Proposal Content Document

Proposal title	Greenbushes Lithium Mine: Waste Rock Landforms, Salt Water Gully Dam and additional clearing for infrastructure.
Proponent name	Talison Lithium Australia Pty Ltd
Short description	Expansion of the existing Greenbushes lithium operations to incorporate the S2 WRL, S8 WRL, SWG Dam and additional mine infrastructure.

Figure 1-8: Salt Water Gully Dam Changes

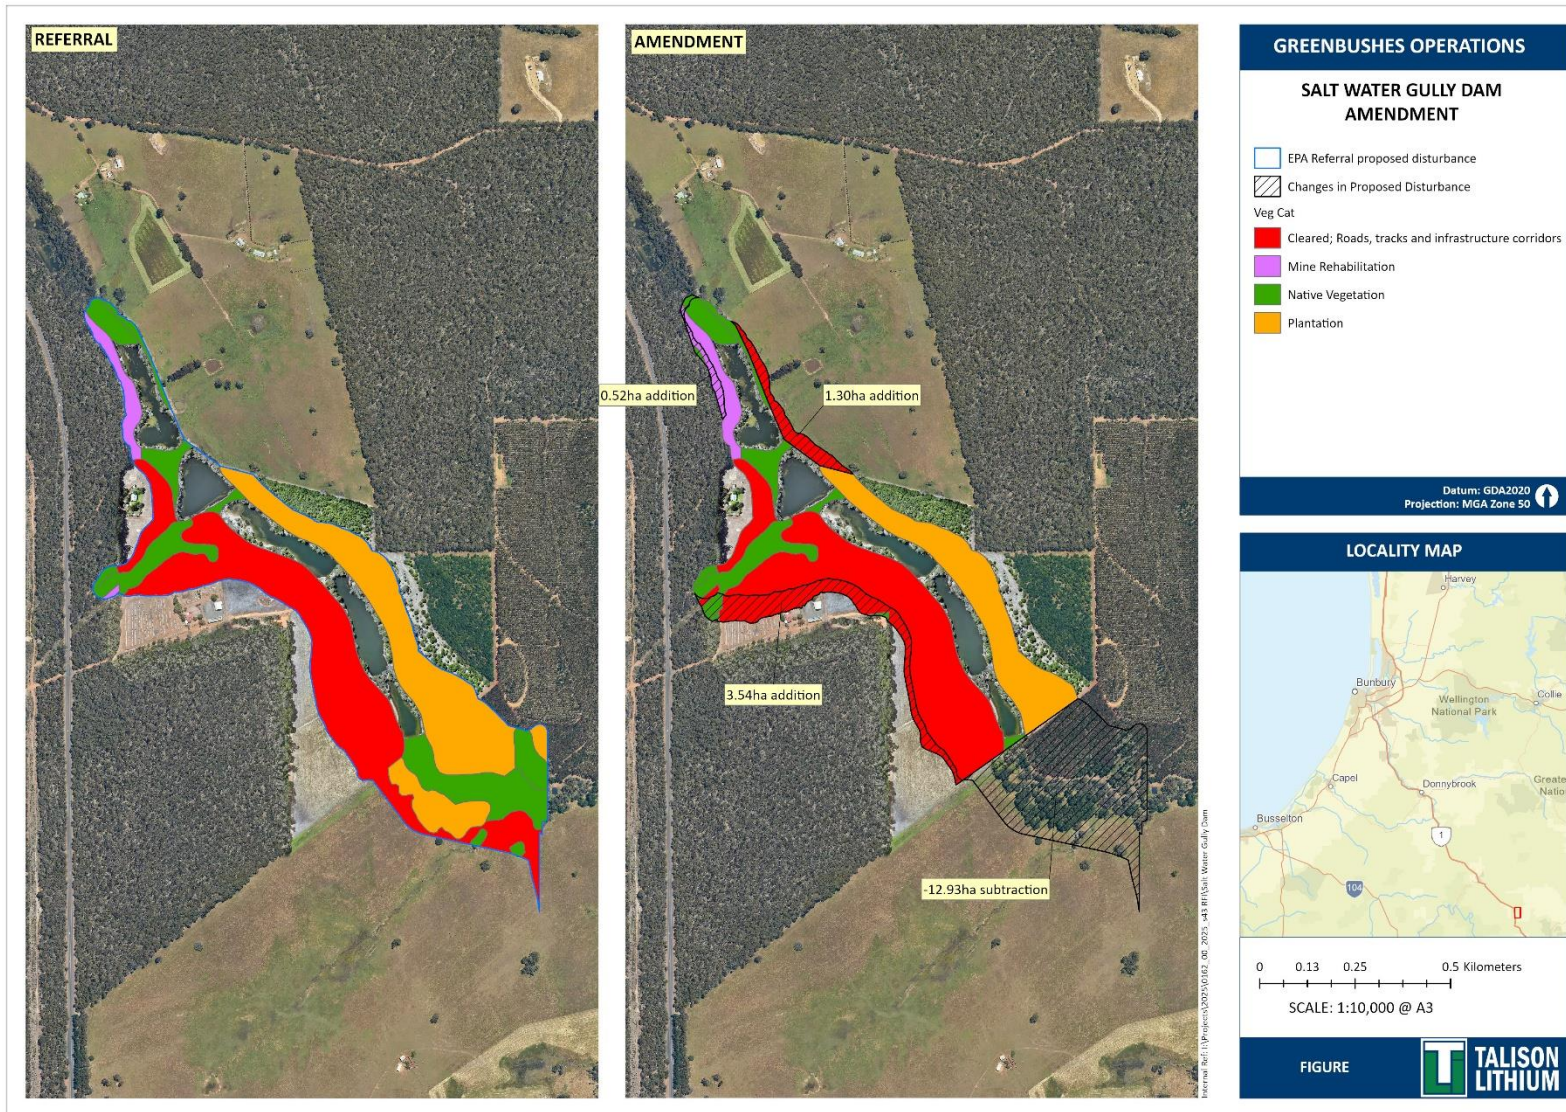
Proposal element	Location/ description	Existing proposal extent, capacity or range	Referred proposal extent, capacity or range	Proposed amendments	Total proposal extent, capacity or range
				<ul style="list-style-type: none"> S8 WRL increases by 2 ha No change to overall disturbance footprint for this element 	
Saltwater gully dam	Figure 1-8.			Reduction of dam area to avoid heritage identified by Wagyl Kaip survey in November 2025. Reduction of 3 ha of native vegetation clearing and reduction 4 ha of previous mine disturbance and rehabilitation areas	
Southampton and Austins dams	Figures 1-3 and 1-9.			<p>2 ha reduction in clearing of native vegetation and 1 ha reduction in clearing of previously rehabilitated areas.</p> <p>Dam raise clearing reduces by 3 ha in total.</p> <p>11.75 ha reduction to the DE.</p>
